Subject: Attn: Planning Officer Thomas Burns - RE: Development Application DA2020/1691

Attachments: 4SouthernCrossWay-Objection_DA2020-1691-FIN.pdf; 4SouthernCrossWay-Objection_DA2020-1691-Plans_ljrMarkup.pdf;

RE: Development Application DA2020/1691

New - Demolition works of existing dwelling and construction of dwelling house, secondary dwelling and studio at 4 Southern Cross Way Allambie Heights NSW 2100.

3PM SHADOW DIAGRAM
WINTER - JUNE 21

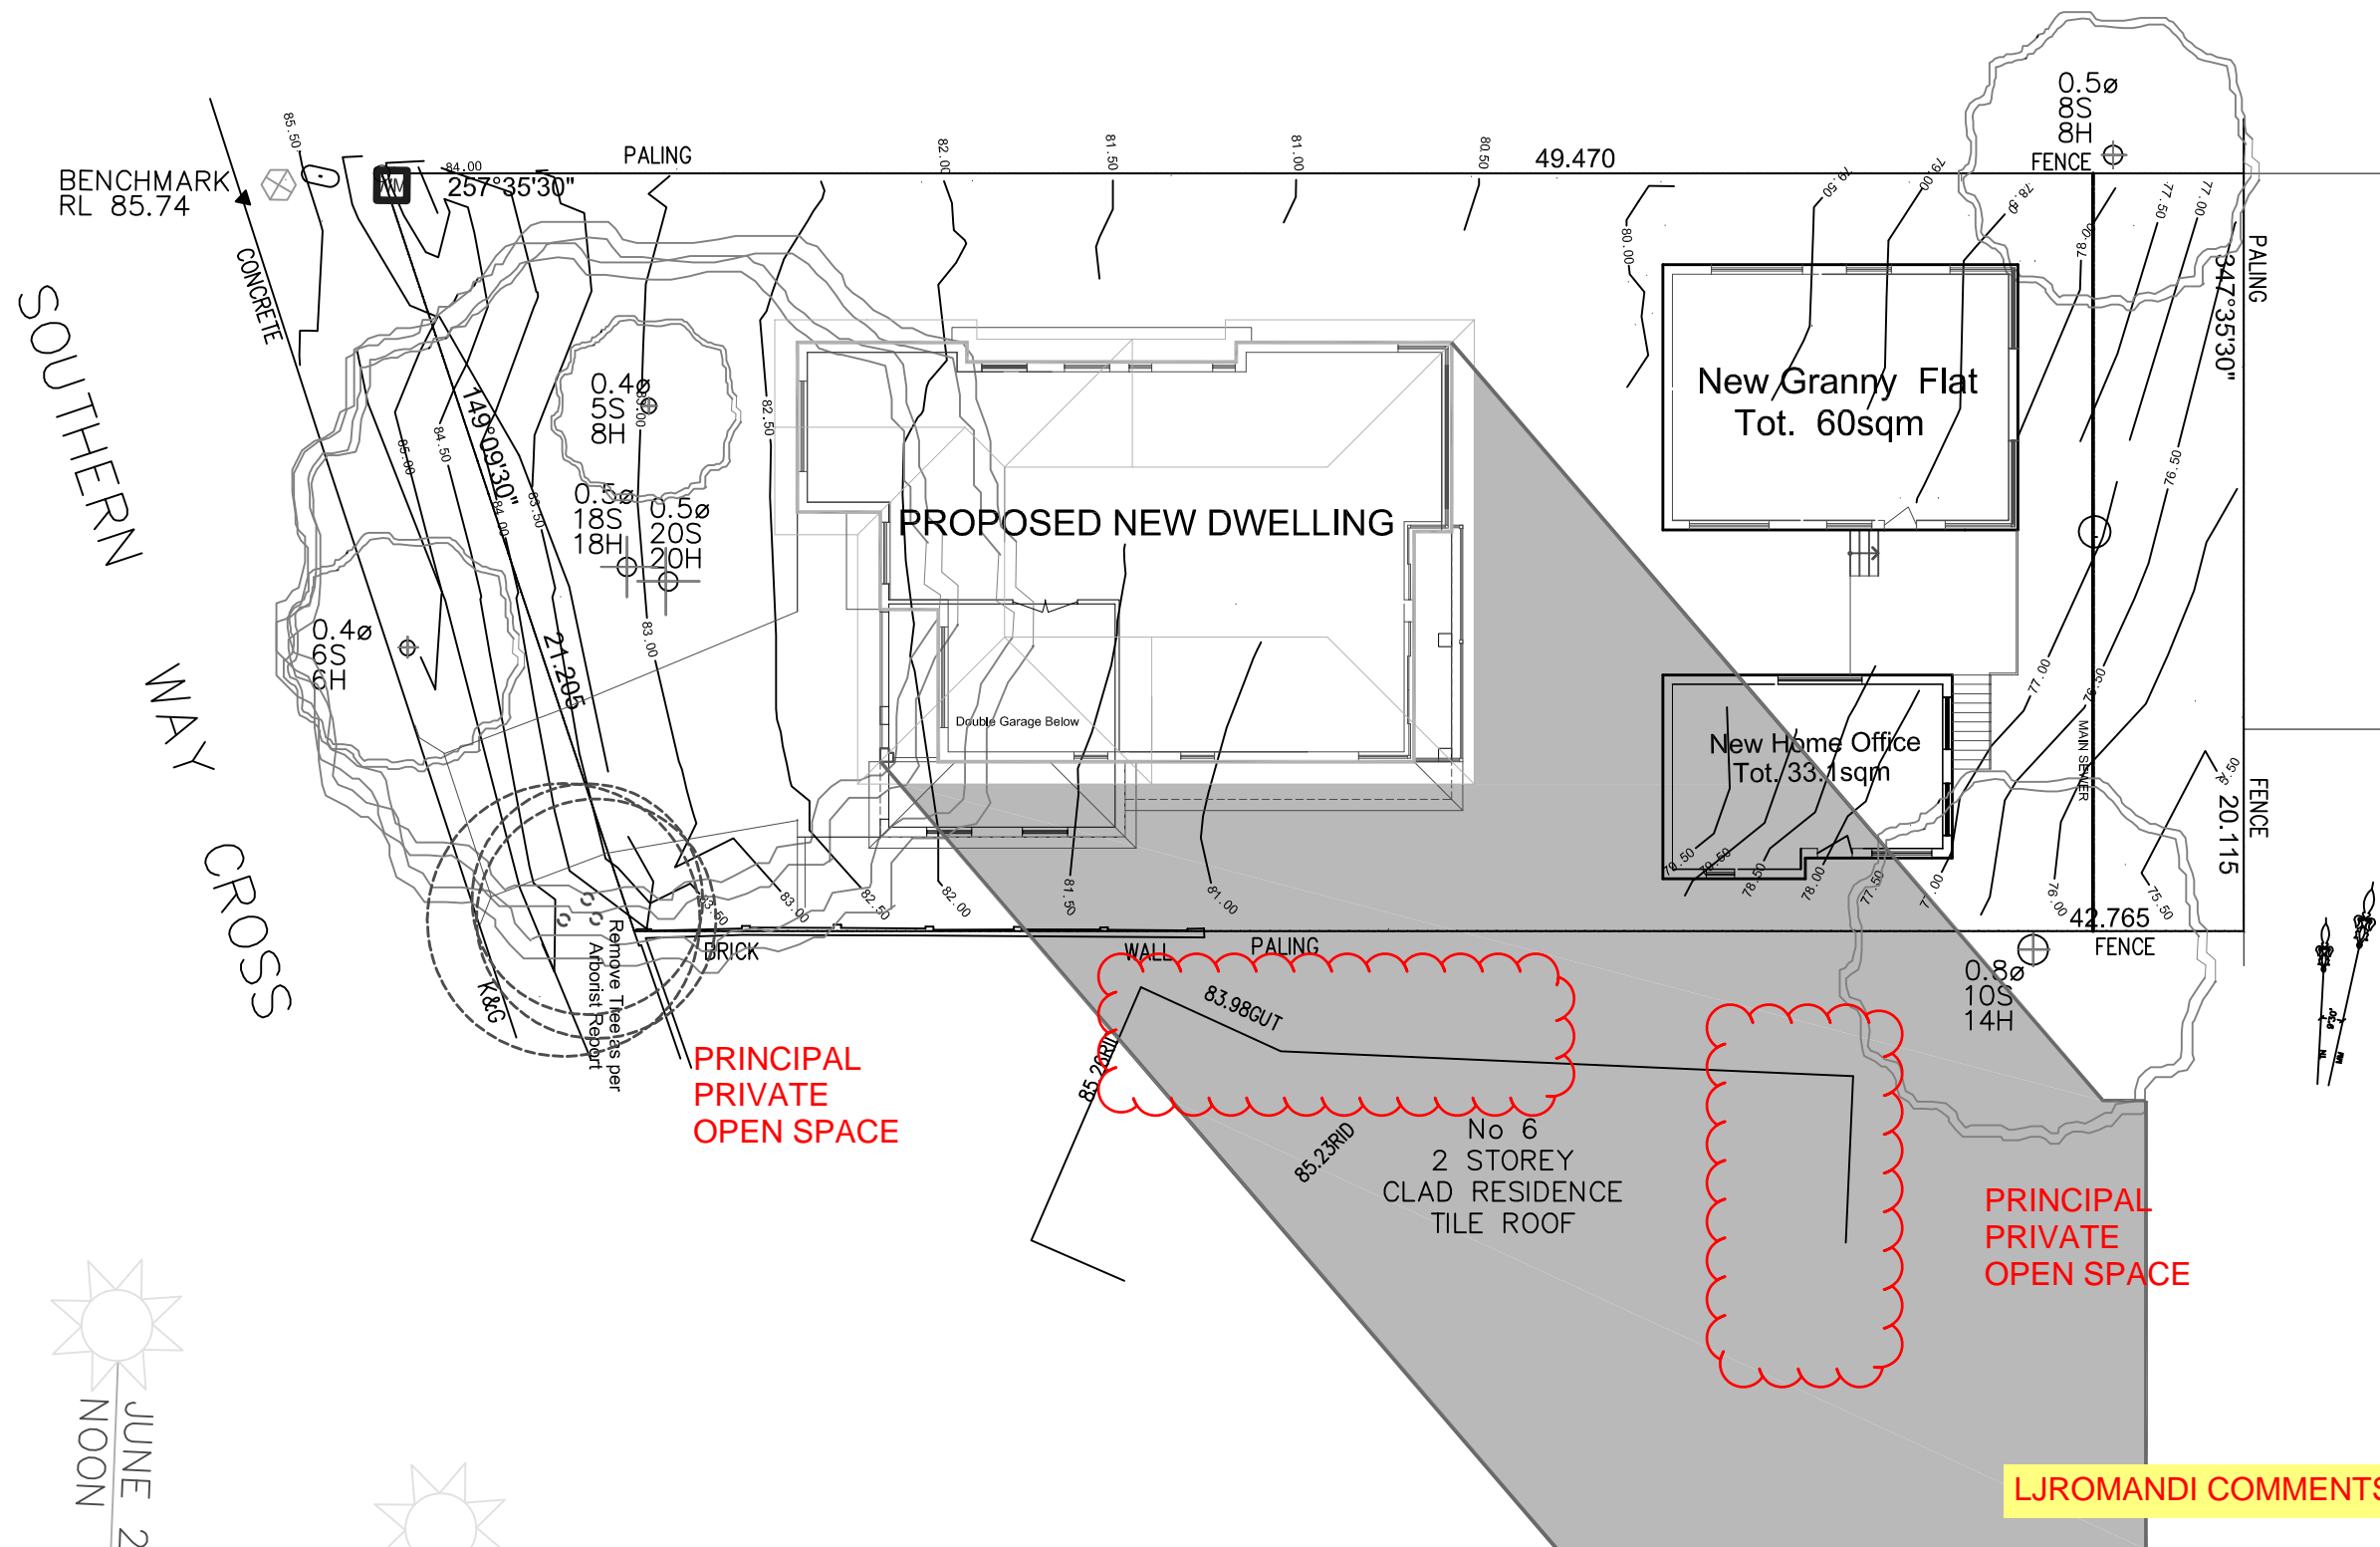
No shadows have been shown generated by the secondary and tertiary buildings to the East. We believe shadows generated from these structures will also impact negatively on our *Principal Private Open Space*.

Although only the Winter solstice shadows have been provided, it would appear that our swimming pool and front terrace area is cloaked by shadow for the majority of the day, only receiving sunlight ~2pm onwards, for what would be less than two hours. Similarly, the master bedroom and other habitable spaces on the northern side of our home would be completely obstructed from sunlight from 9:30am onwards.

LJROMANDI COMMENTS 19.03.2021
